# DESIGN COMMISSION

**CITY OF MERCER ISLAND  
DESIGN COMMISSION  
STUDY SESSION STAFF REPORT  
MAJOR NEW CONSTRUCTION**

| Project:         | Xing Hua Group Ltd Mixed-Use Project (DSR18-018)   |

**MERCER ISLAND DESIGN REVIEW STUDY SESSION #2**

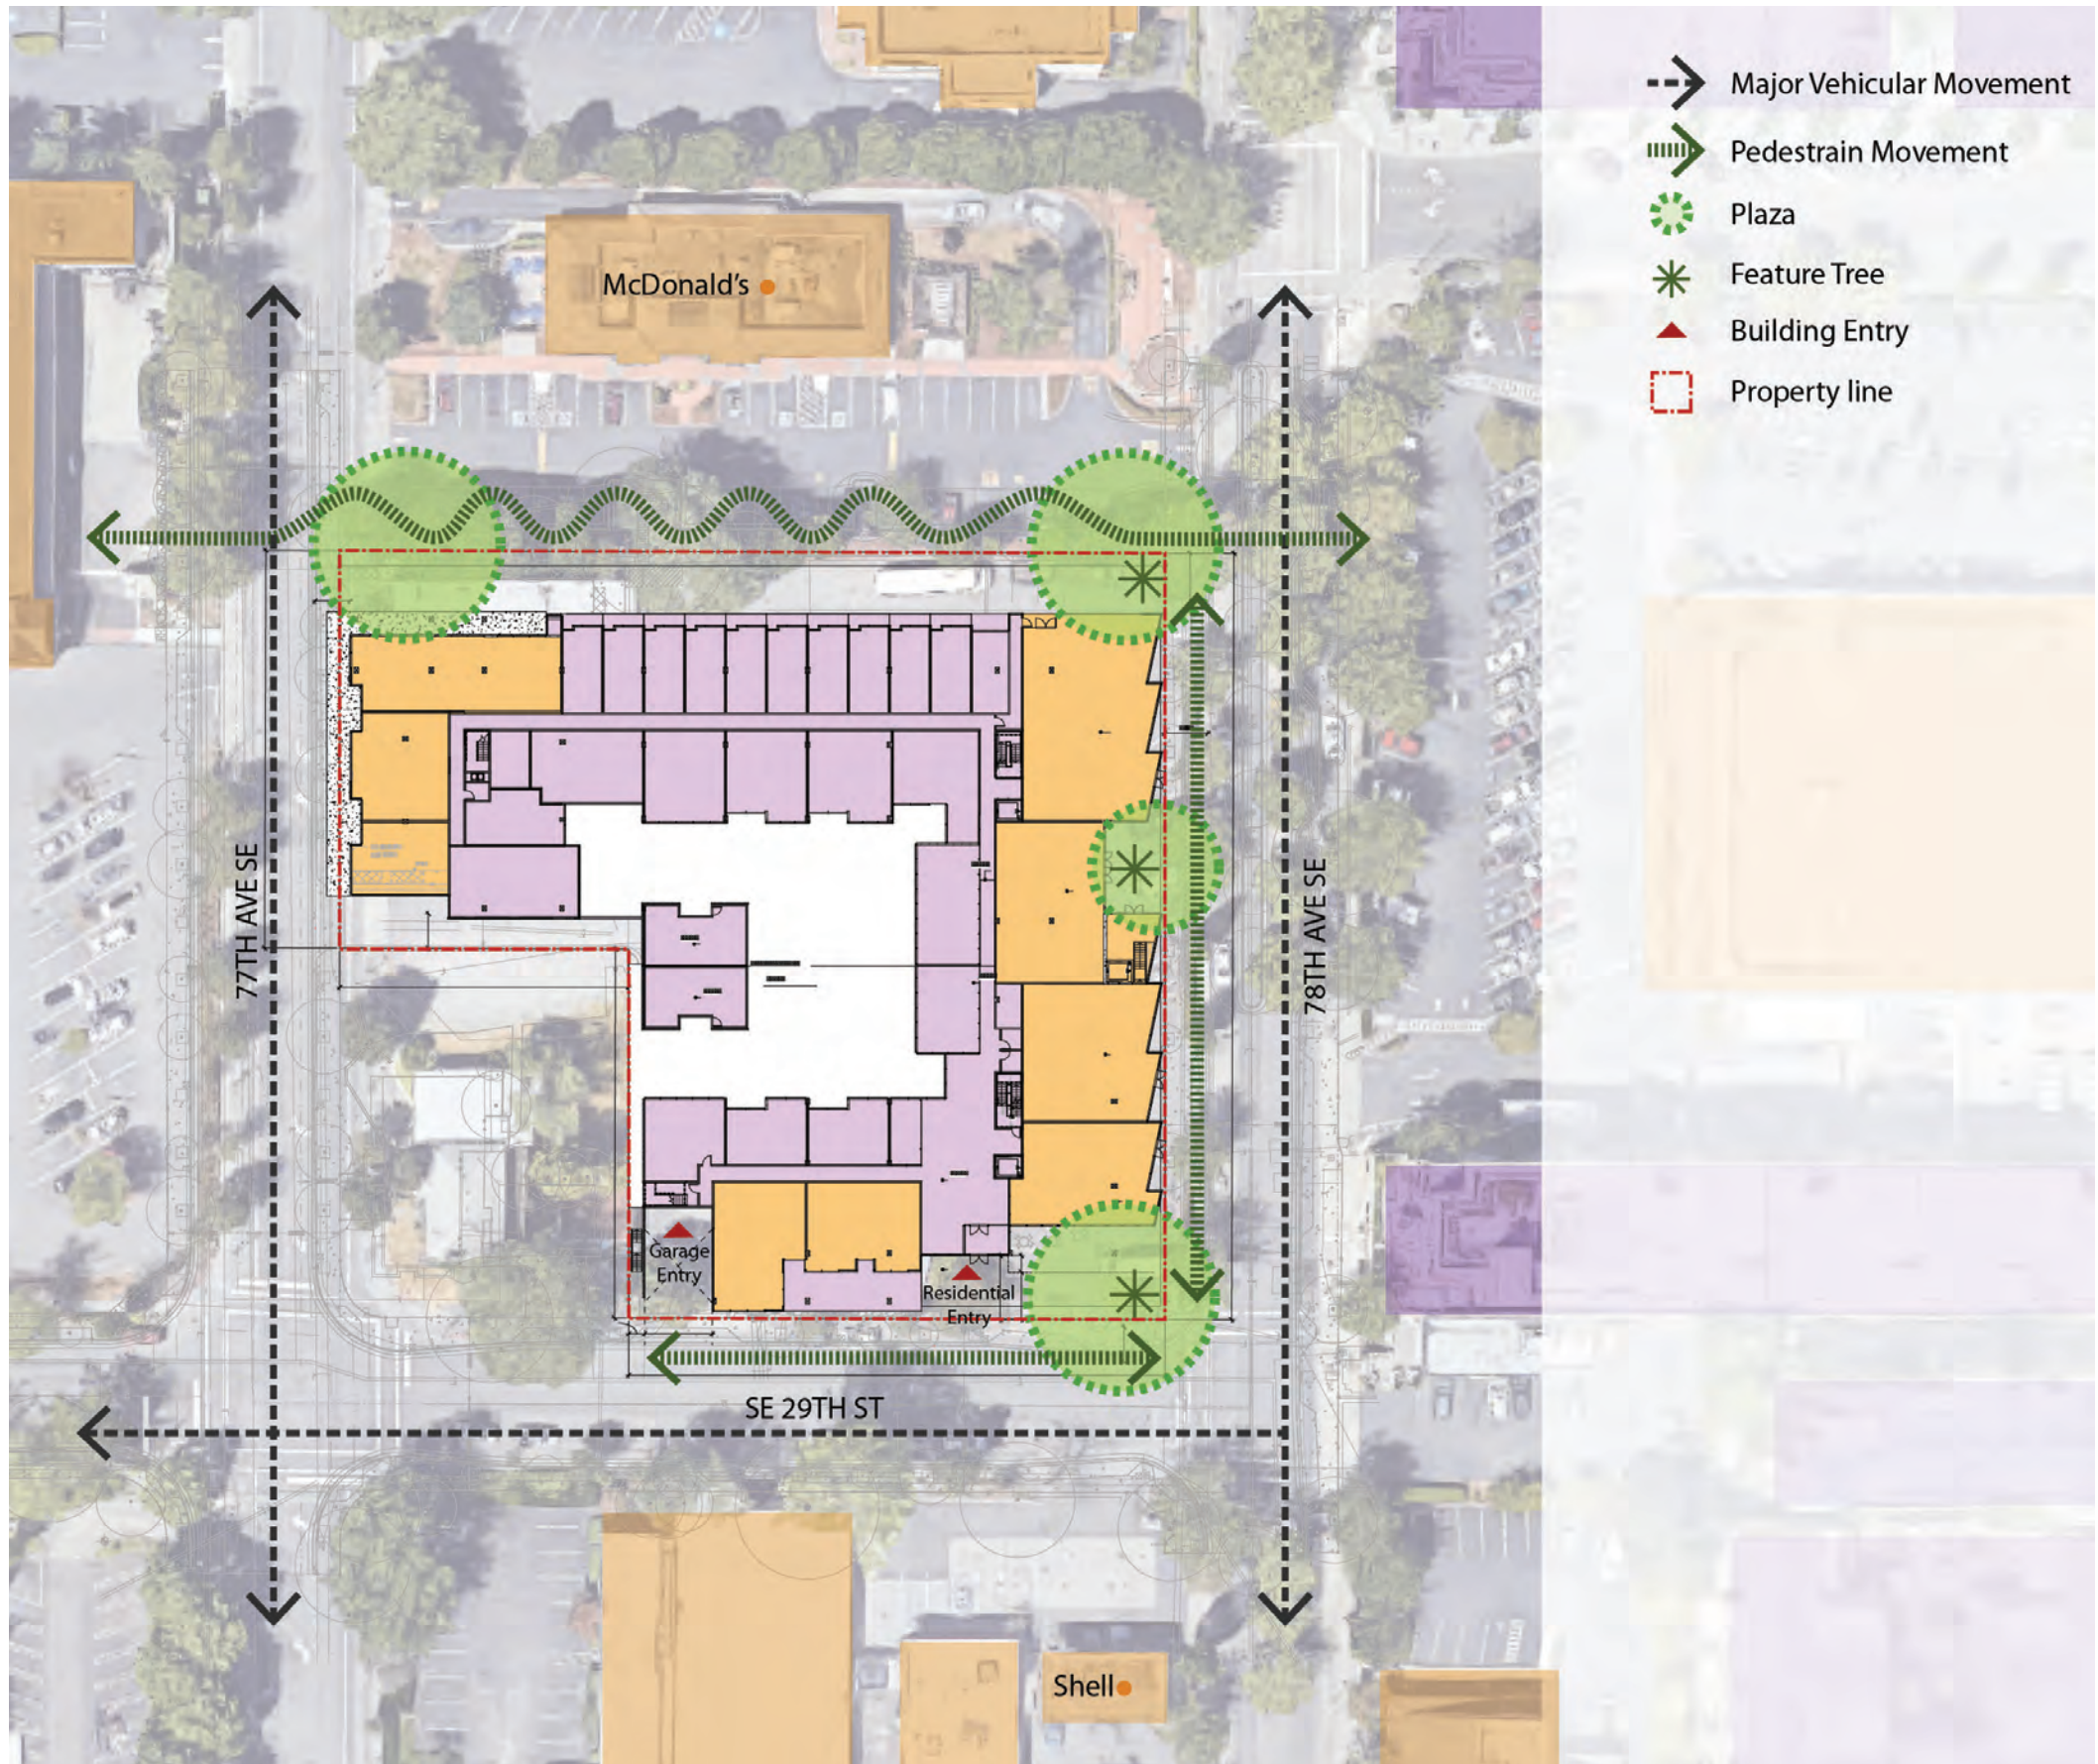
**BOARD COMMENTS:**  
*-creating an asset to the community*  
*-sensitivity to the pedestrian scale*  
*-feeling of openness*  
*-improve on the building modulation*  
*-Mercer Island spirit captured in public areas*

# **BUILDING MASSING & MODULATION**

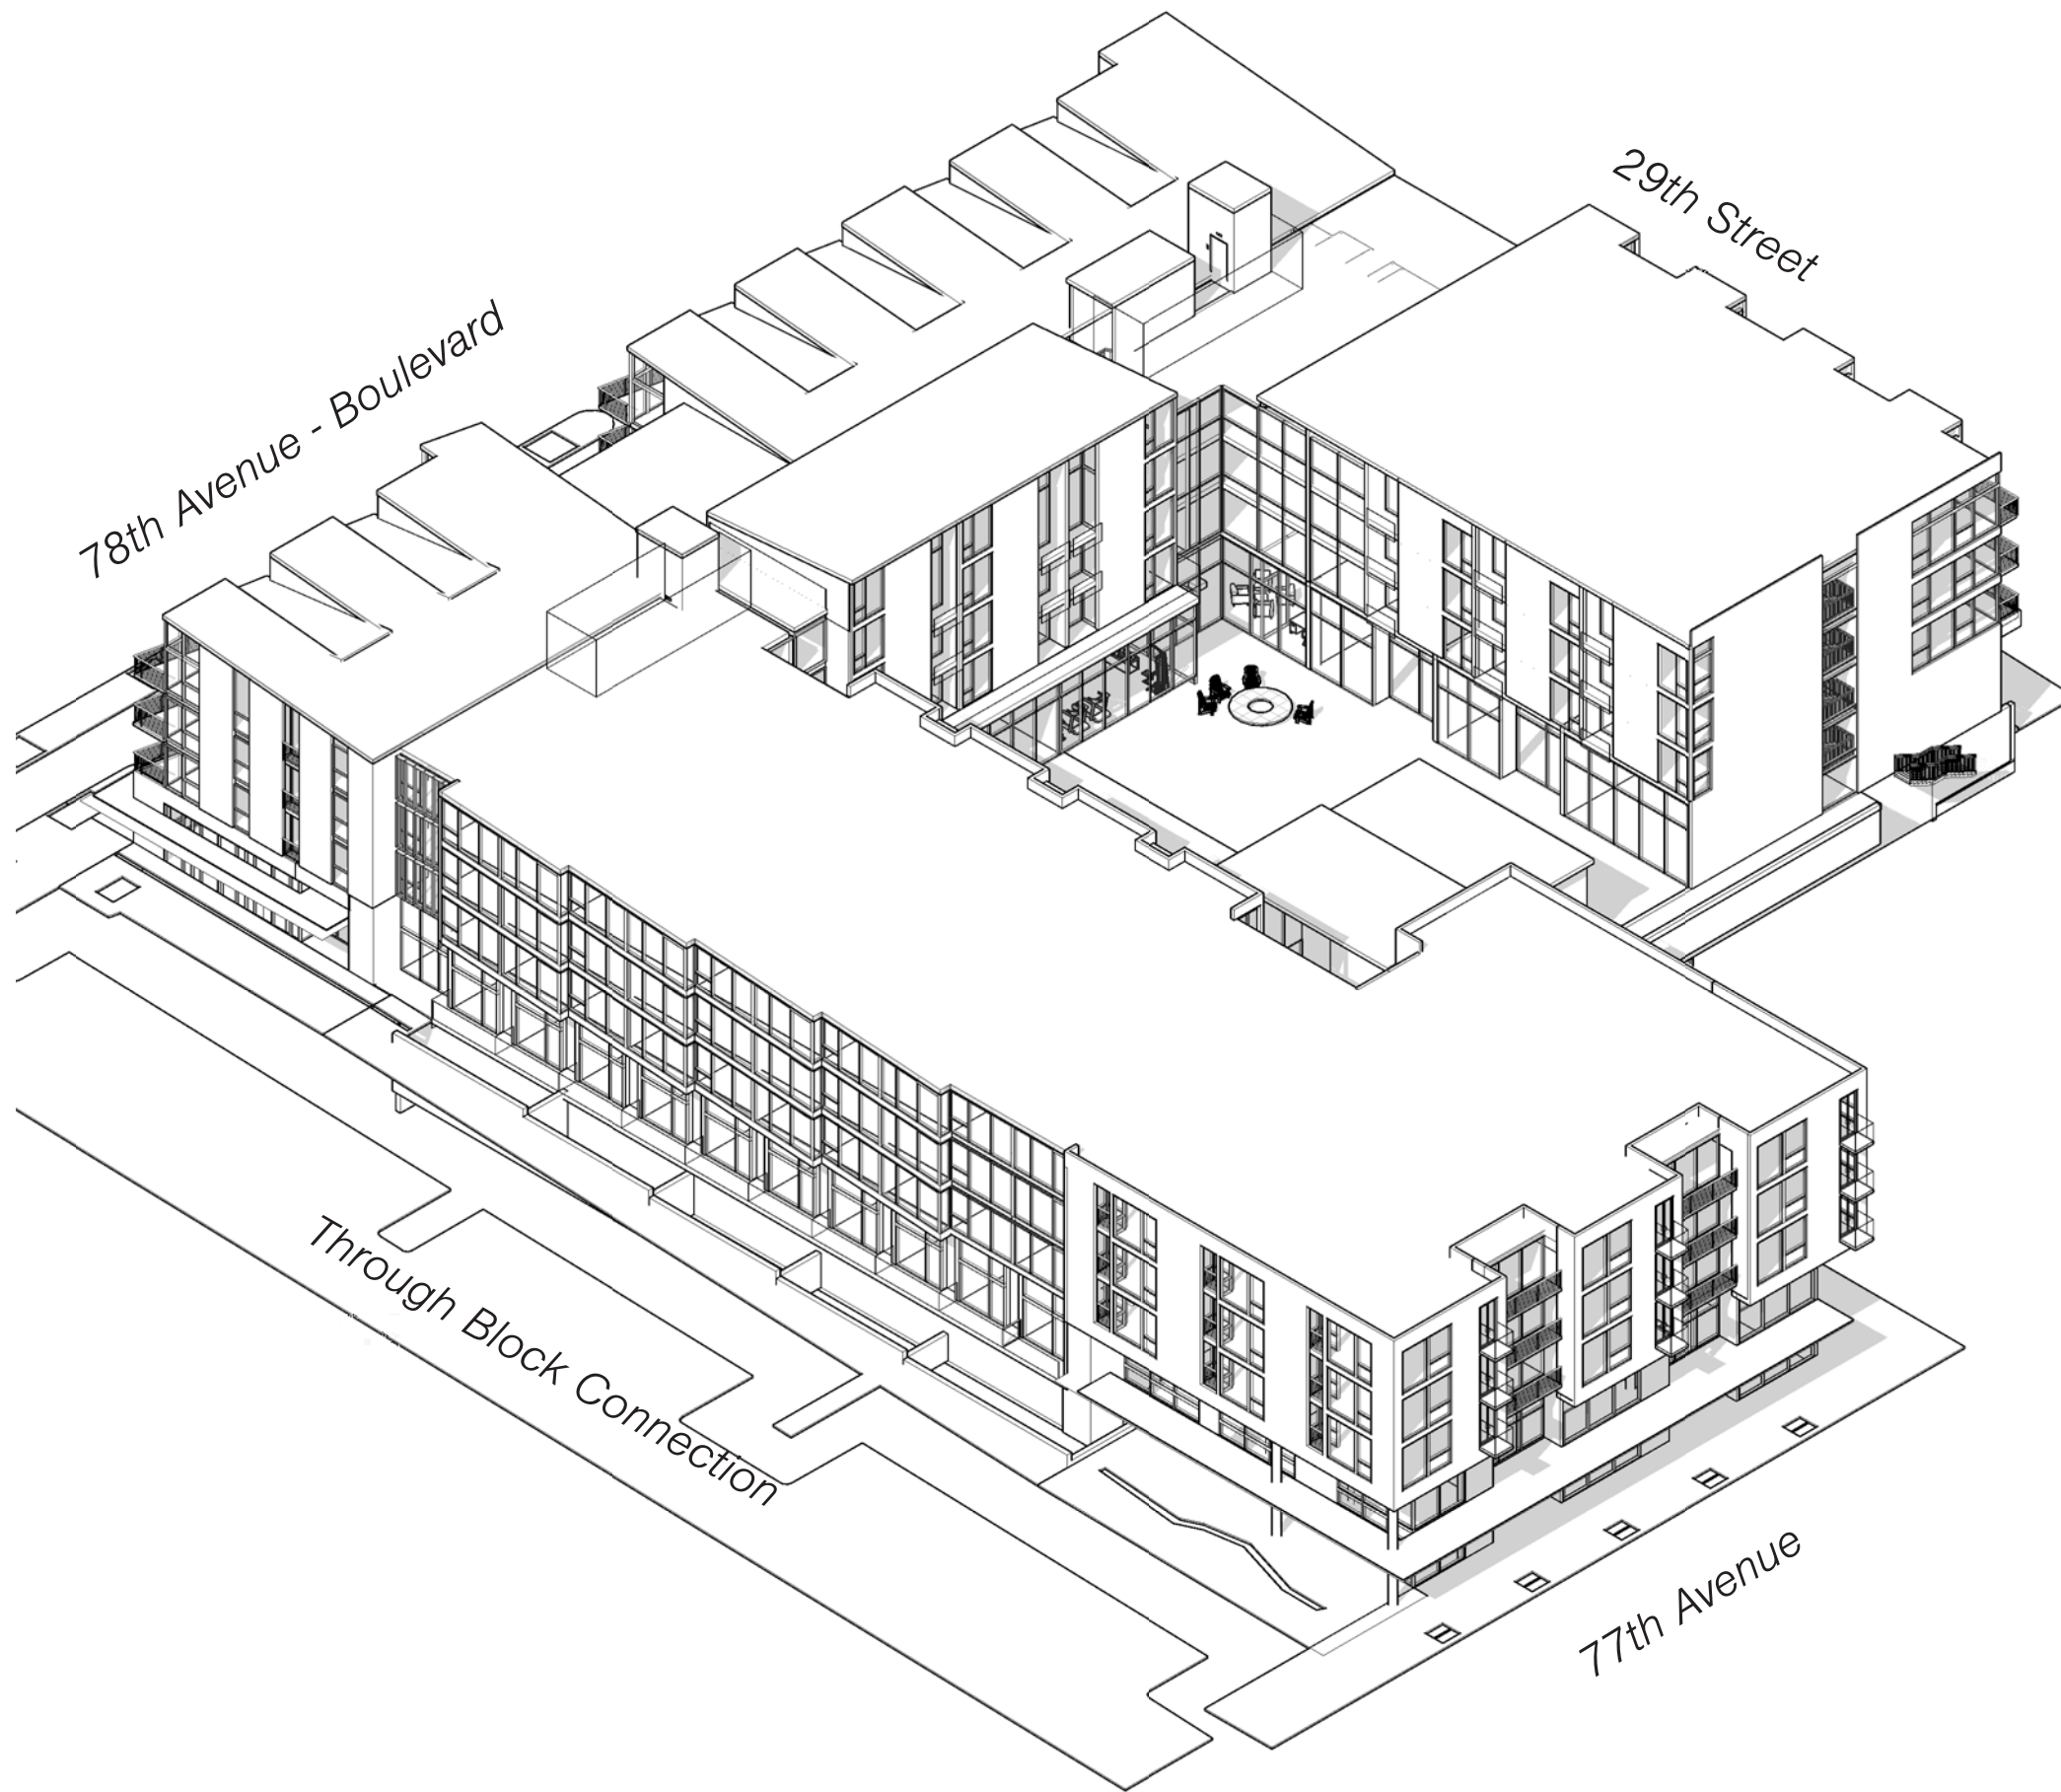
**BOARD COMMENTS:**

*-consider how to distribute the massing into more distinct buildings*

*-keep sloped roof modulation under the height limit and reduce the perceived scale*

*-continue to develop the vertical bays and how they are articulated*

*-be mindful of large brick proportions*

*-more articulation of the south facade facing the plaza*

*-be mindful of the pedestrian scale at the retail street levels*

*-improving the scale of the south plaza*

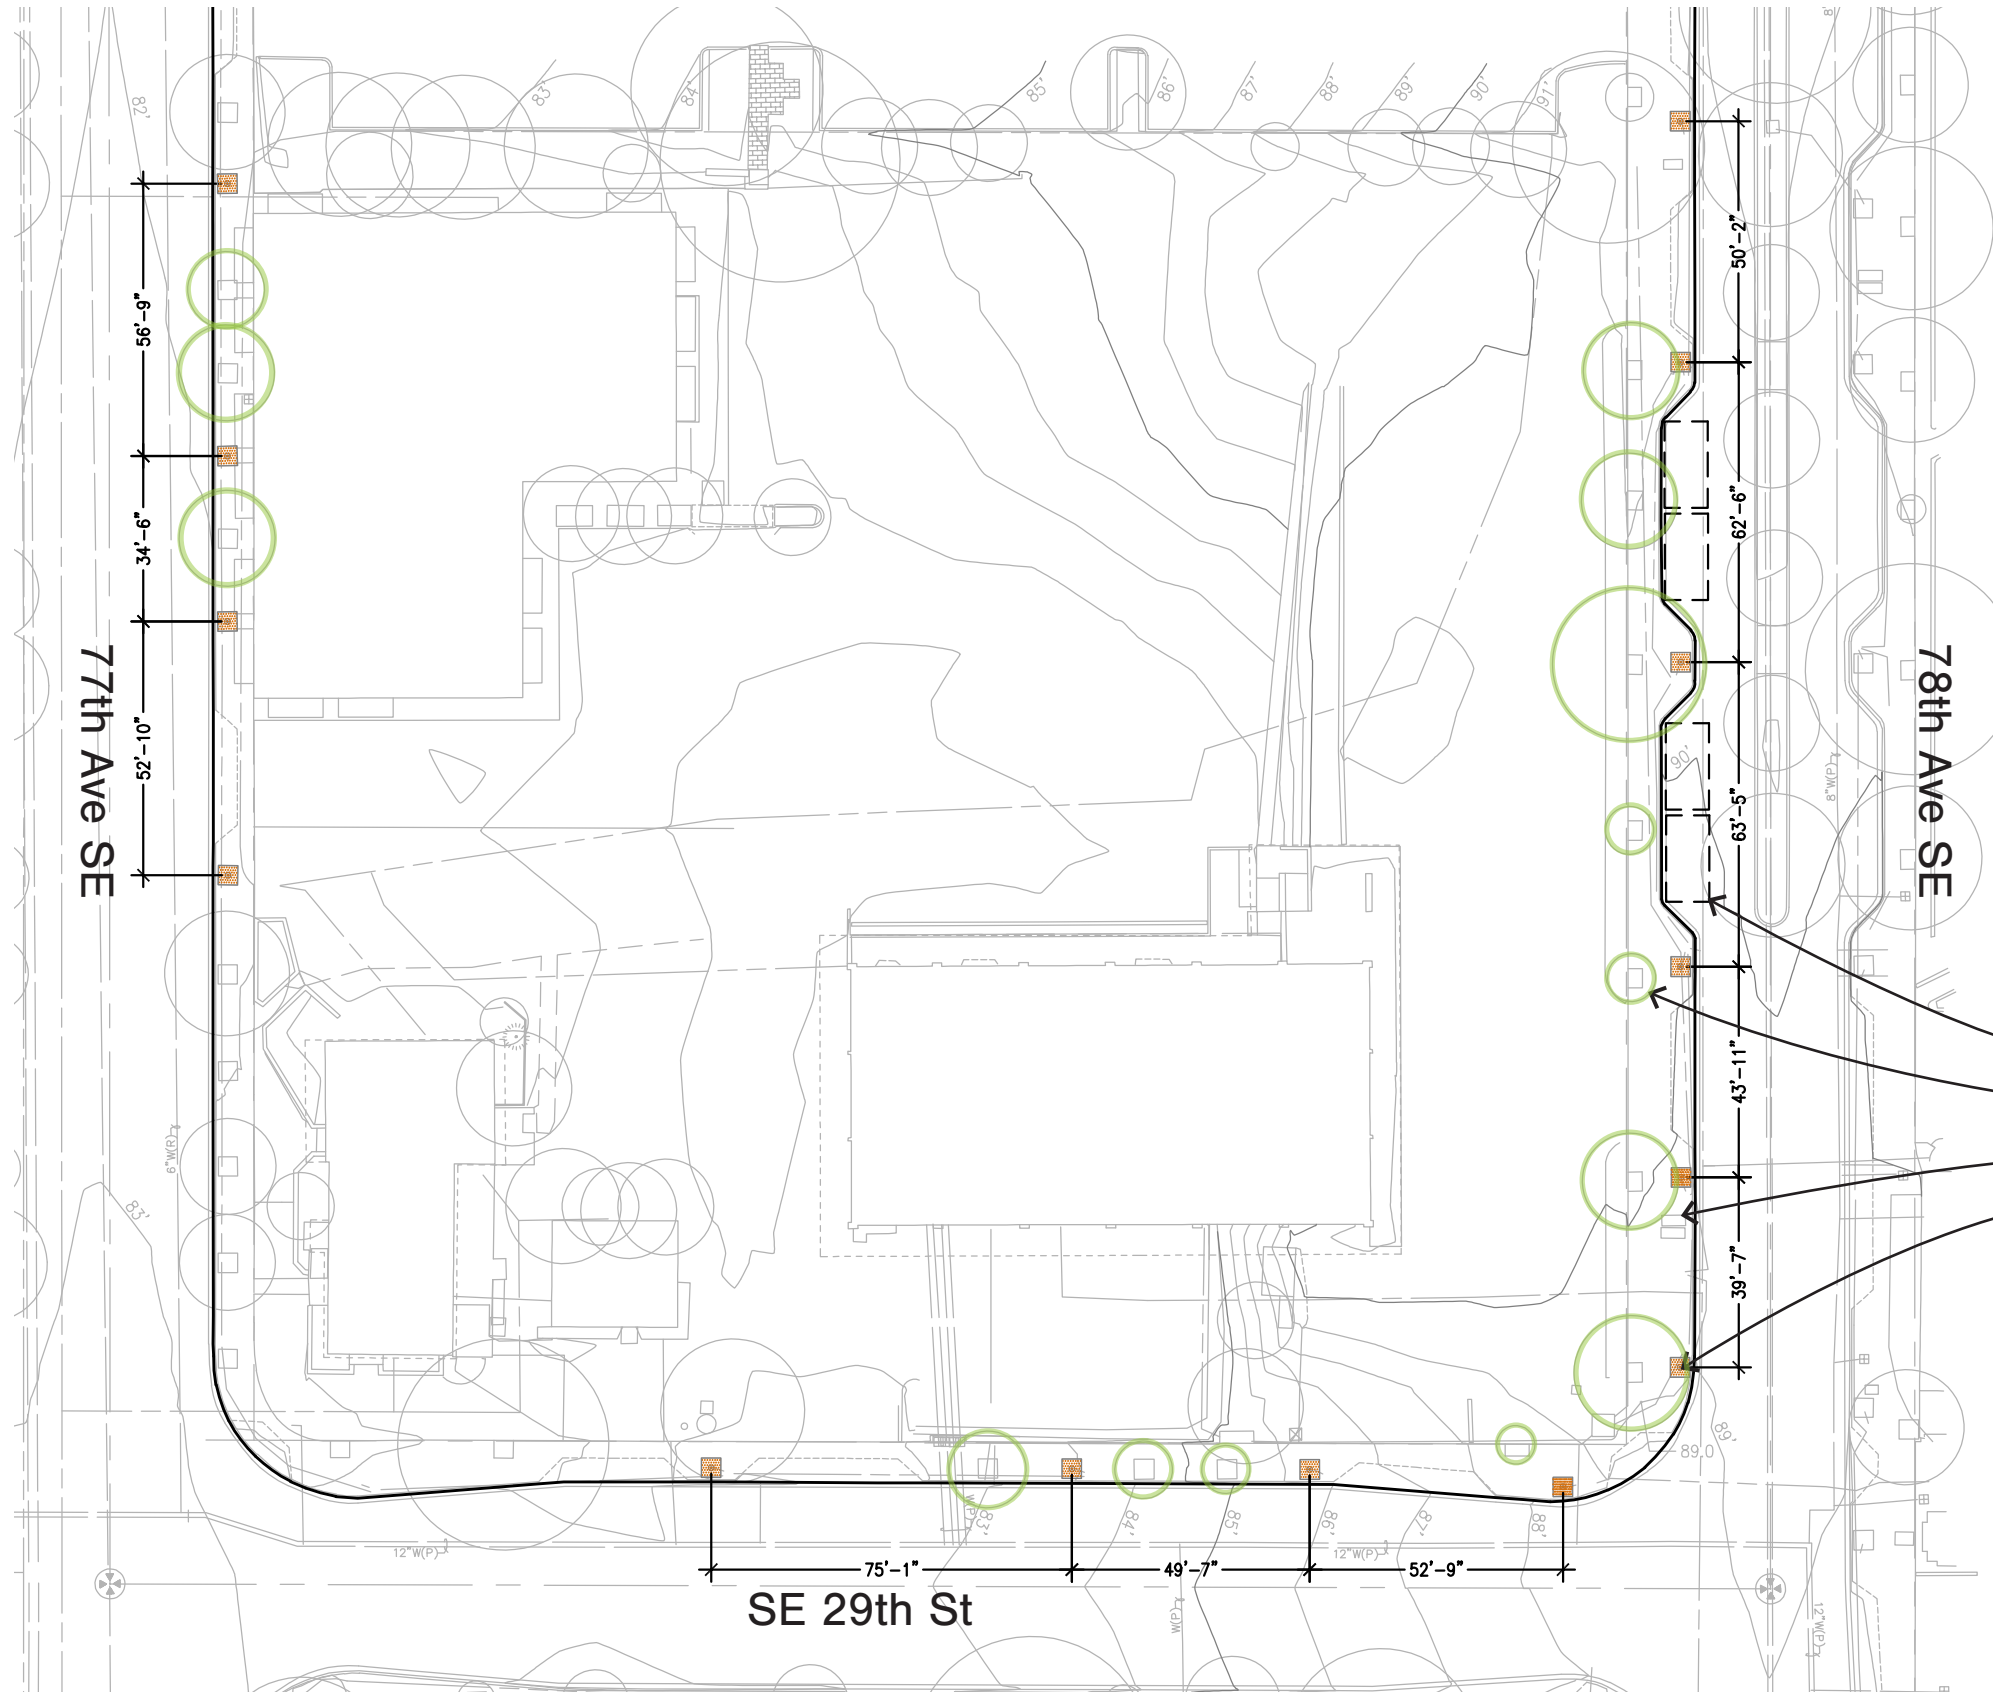
**BOARD COMMENTS:**

- consider how to distribute the massing into more distinct buildings
- continue to develop the vertical bays and how they are articulated
- be mindful of large brick proportions
- be mindful of the pedestrian scale at the retail street levels
- develop and refine the 77th Avenue facade
- more development and articulation of the elevation at the thru block connection
